EAGLE GOLD PROJECT

HEAP LEACH FACILITY CONSTRUCTION SUMMARY REPORT FOR PHASE 1A

PROJECT NO.: 0792023 DATE: September 24, 2019

DWG No.: FIGURE 13

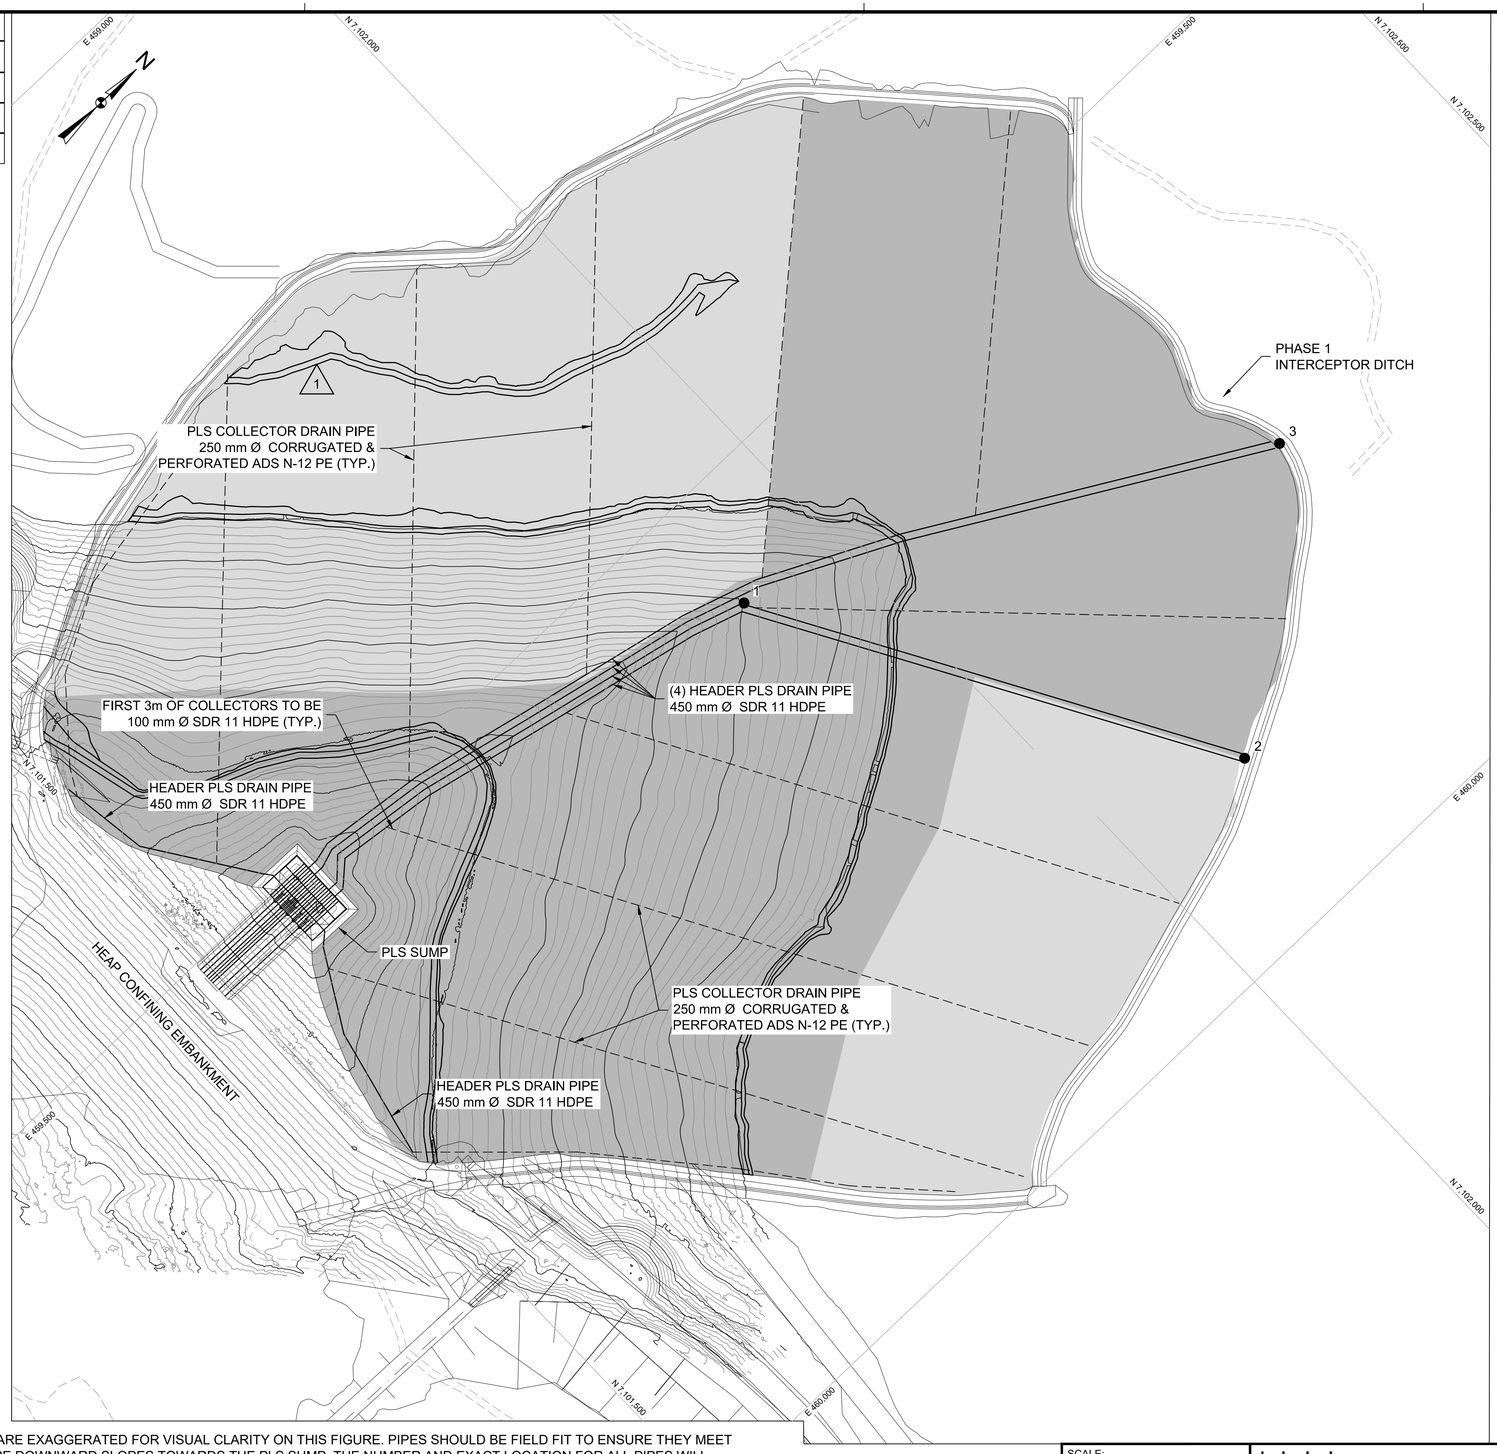
The use of 16mm ore as ODF is approved. Pipe spacing should be 16m when placed on slopes less than 2.5:1 and 22m when placed on slopes greater than 2.5:1. This spacing is dependent on 1 meter of ODF thickness. Spacing calculations are included in ***Attachment 2***. A figure that includes this spacing applied JDS's subgrade below 990m and the 2018 revisions to the heap pad boundaries is included as ***Figure 13***.

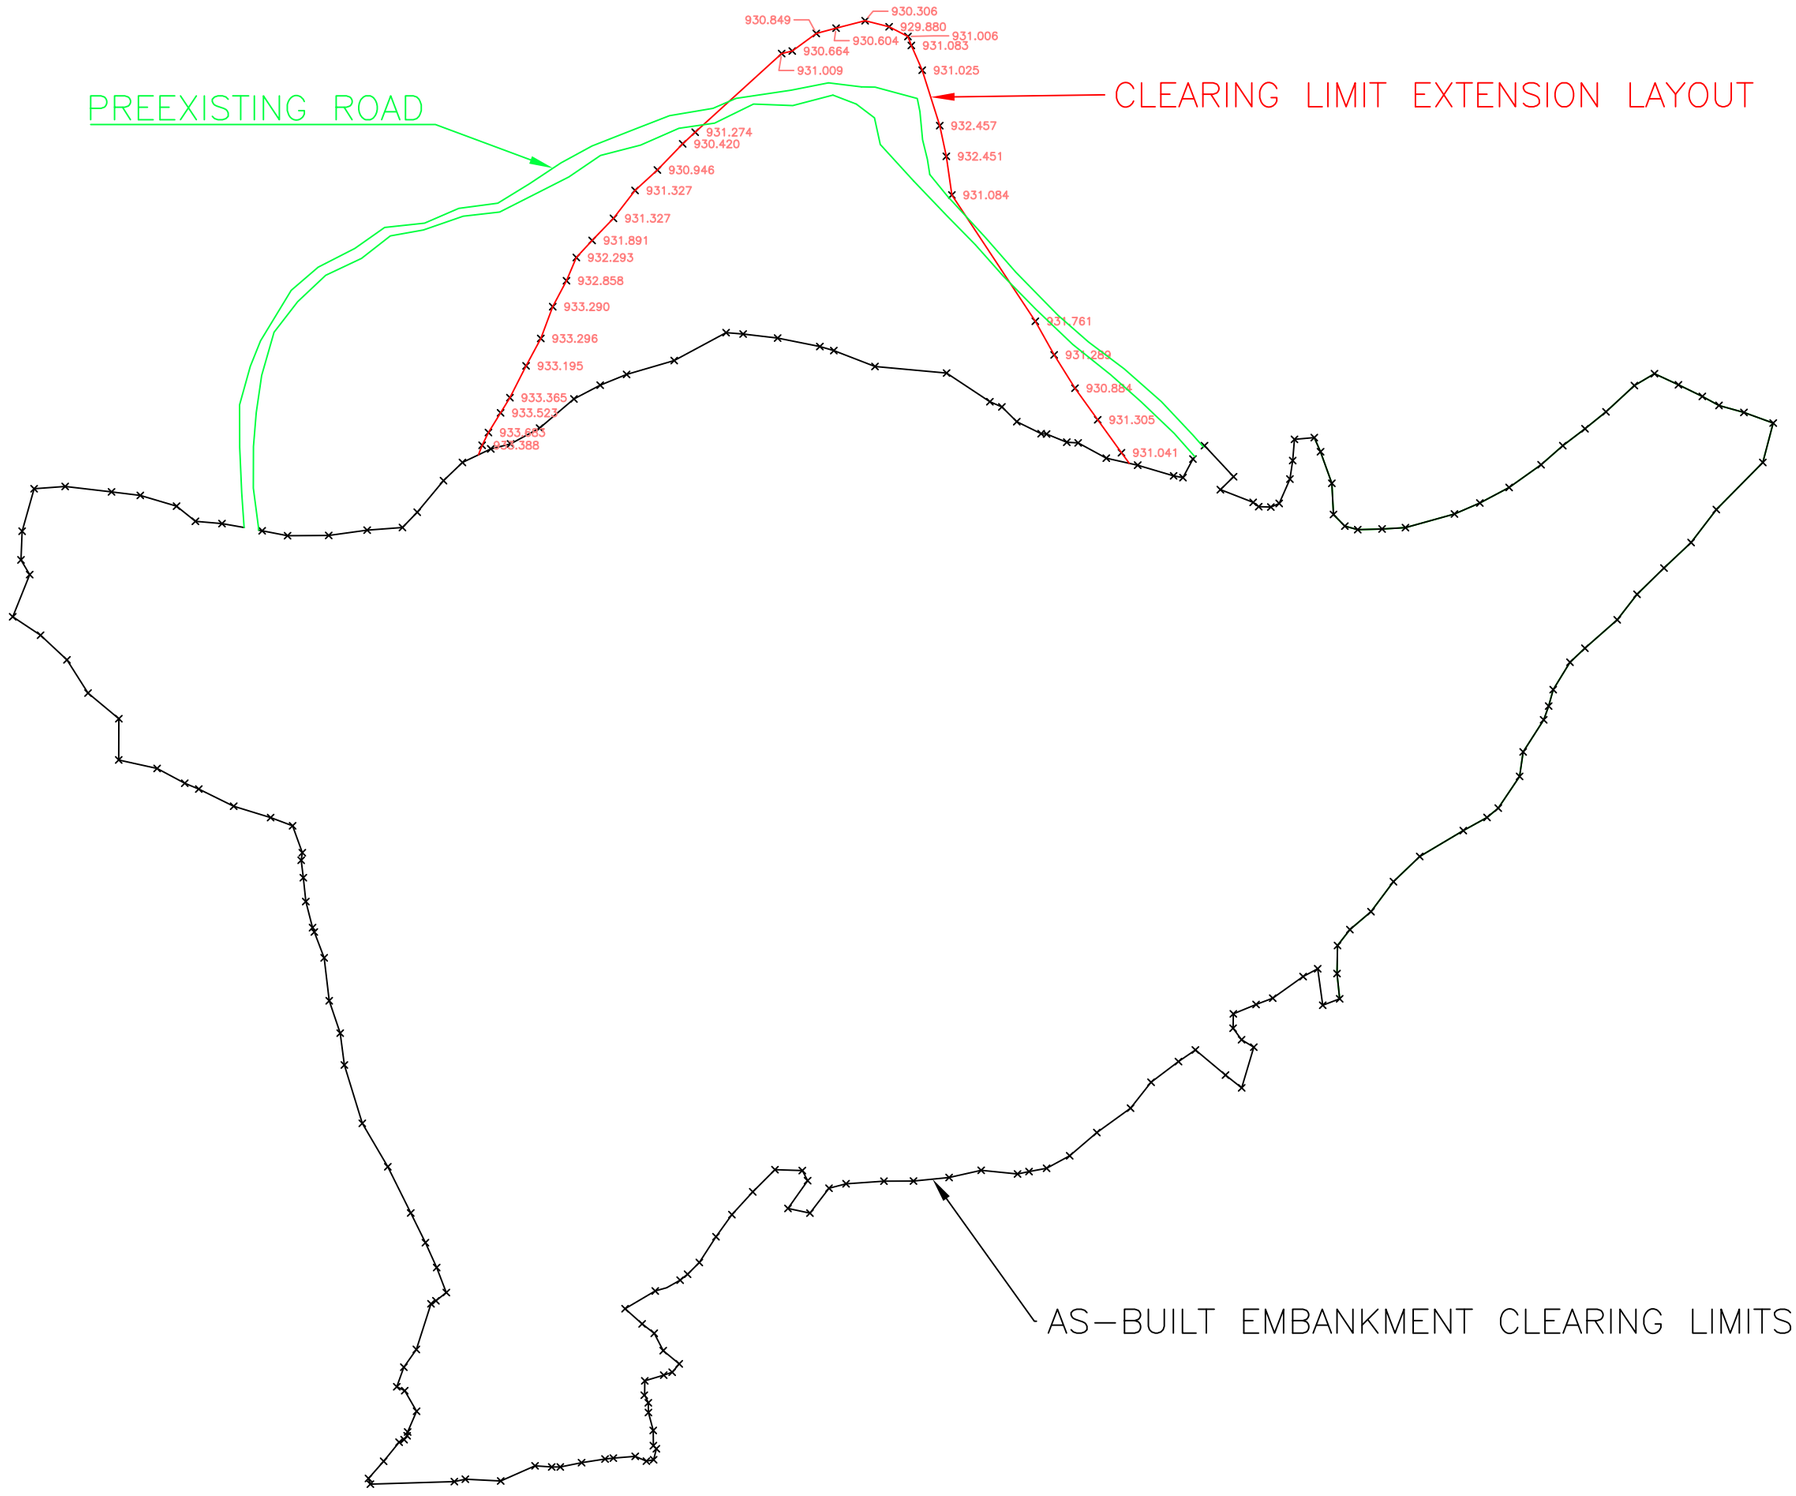
1: Contractor to clear area required to access the in-heap pond sump safely and practically.

2: BGC agrees and approves the continuation beyond the closure sump for off-season protection as described. The transition to 160mm DR9 pipe will occur at approximately Station 0+400. Please advise if this length beyond the closure sump I adequate for this year's construction.

3: Contractor to proceed with establishing diversion ditches upslope of works. Contractor to propose alignment of ditches for review to EPCM supervisor for approval prior to proceeding.
